**Development Review Board
Panel A Meeting
October 12, 2020
6:30 pm**

A. **Resolution No. 381. I & E Construction: David Hardister, Woodblock**

Case Files: DB20-0033 Site Design Review
 DB20-0034 Class 3 Sign Permit and Waiver

Exhibit A1
Staff Report
Wilsonville Planning Division
I&E Construction – Exterior Changes and Sign Waiver

Elevation showing proposed vertical trellis structures and greenery

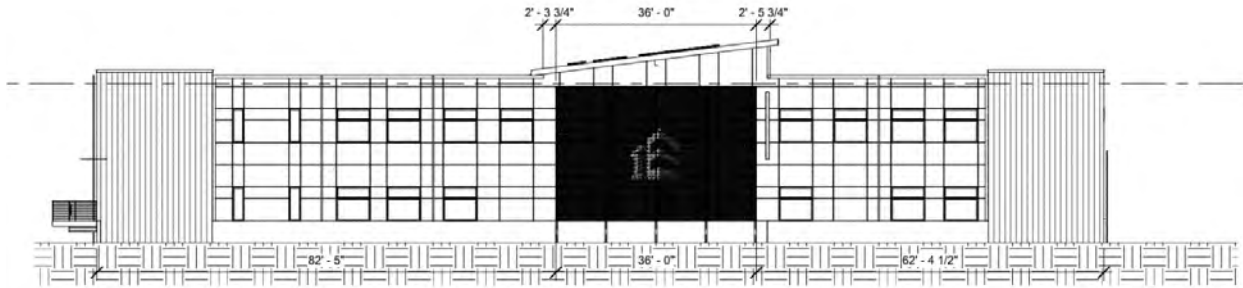
At the August 10 hearing, the DRB members requested additional renderings integrating a color change to break up the front façade where the metal panels are installed at the center of the building. The applicant responded with the above rendering that incorporates white on the southeastern corner of the building to provide additional contrast to the SW Parkway Avenue facing façade. The applicant stated that due to the factory finish of the metal panels, quality and maintenance issues would arise should they be painted. The portion of the façade depicted with white paint is made of fiber cement panels rather than the metal. The three trellis structures that were presented at the August 10 hearing remain. The application provided additional detail regarding the plant type and characteristics. Common Jasmine or Star Jasmine is the recommended plant species by the project Landscape Architect. Both will grow up the trellis structure to a height of 12 feet, require minimal maintenance, and offer the seasonal characteristics desired to maintain greenery on the trellises year-round.

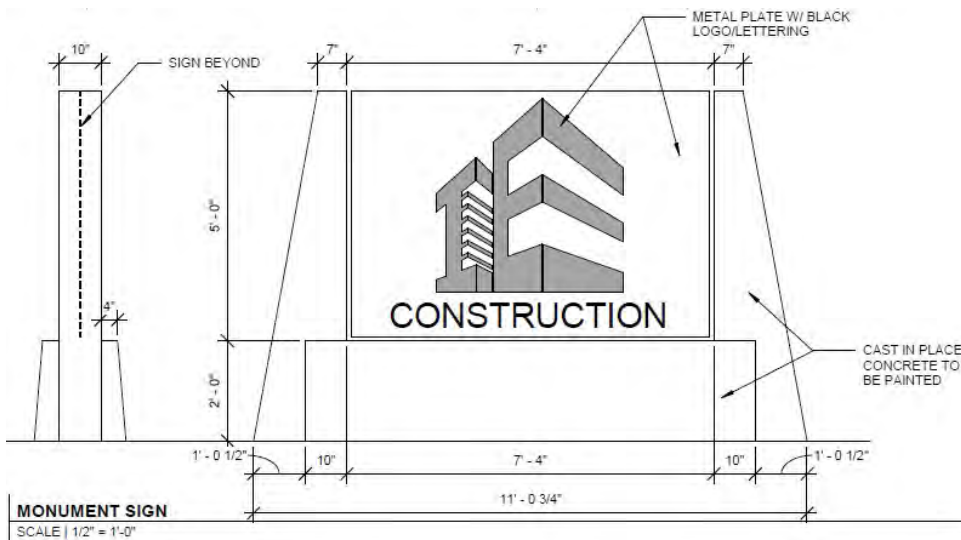
The DRB requested additional renderings of the proposed sign to better understand the location and scale. The above images come from Exhibit B4, which was submitted by the applicant on September 2, 2020.

The proposed building sign and waiver request is for a 134 square foot non-illuminated sign integrated into the perforated aluminum facing I-5. The façade is sign eligible as it faces I-5, and the applicant is allowed 64 square feet of sign area by transferring the allowable sign area from their allowance for a ground mounted sign. This waiver would allow an increase of 70 square feet from the maximum allowable sign area. Integrating the sign into the façade is a unique and innovative way of incorporating the corporate logo onto the building. The logo will be visible through differently sized perforations within the aluminum screen wall and will add additional visual interest to the building.

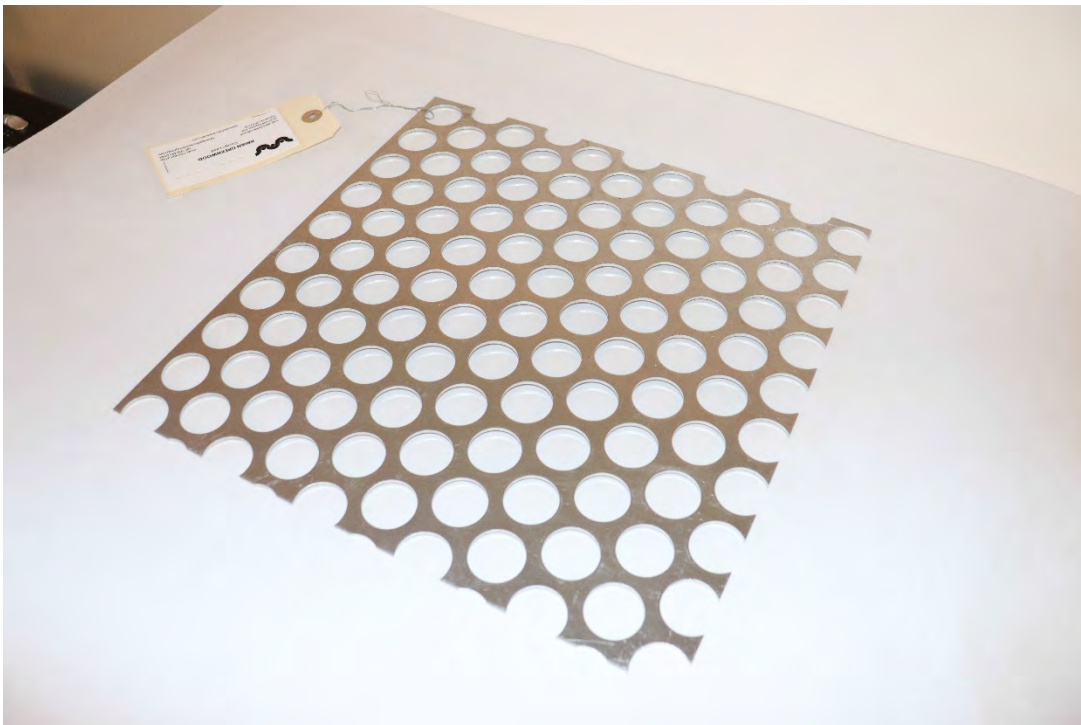
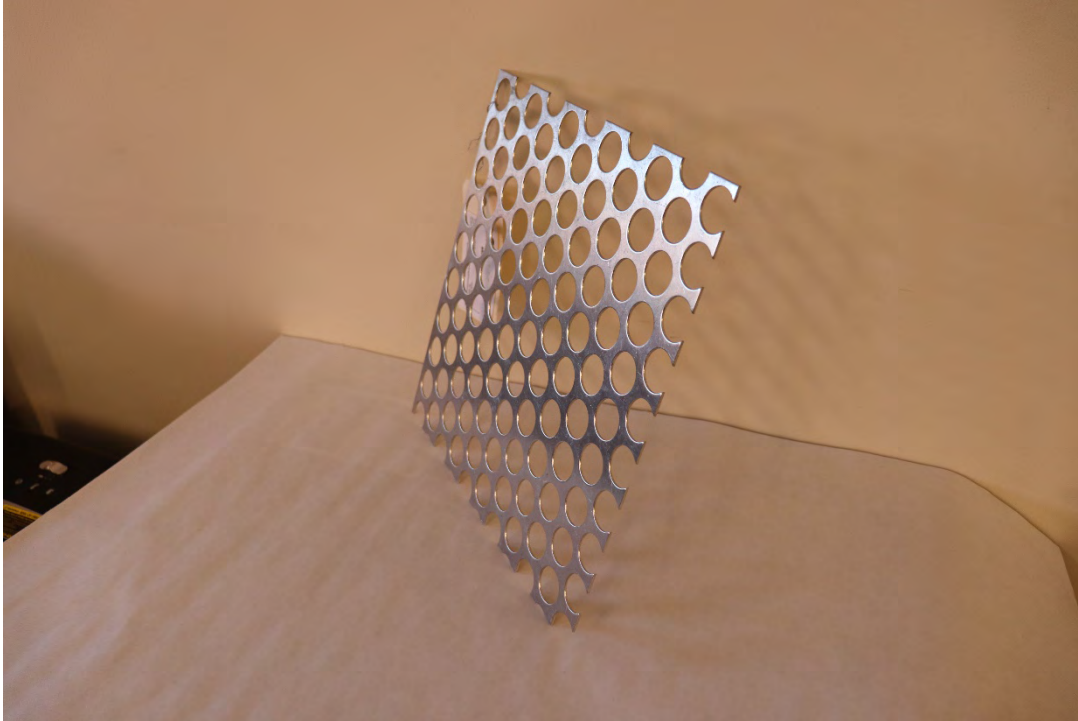
The image above shows the sign at 134 square feet within the context of the overall building. At this size the sign is still subtle and differs significantly from traditional sign types such as a cabinet sign, a freestanding ground sign, or channel letters on a raceway attached directly to the building. The logo is integrated into an architectural feature of the building and does not incorporate additional materials, colors, or lighting. More traditional signs would contain colors, illumination, and other elements that would draw more attention to the sign and associated business. The I&E sign is sufficiently unique that it would not set a precedent for approving more traditionally constructed signs above the 64-square foot sign maximum.

The applicant also provided additional renderings of the sign from various angles and distances to illustrate how the legibility of the sign changes depending on the size of the logo. As seen in the image above the 134 square foot proposed sign is legible from I-5, however should the sign be reduced to 64 square feet in the image on the right, the appearance of the logo is barely noticeable within the screen wall. With the additional details and information provided by the applicant, the sign meets the compatibility standard as it is proportional to the building and site, maintains a cohesive look with adjoining properties, and is appropriate for the zoning district.
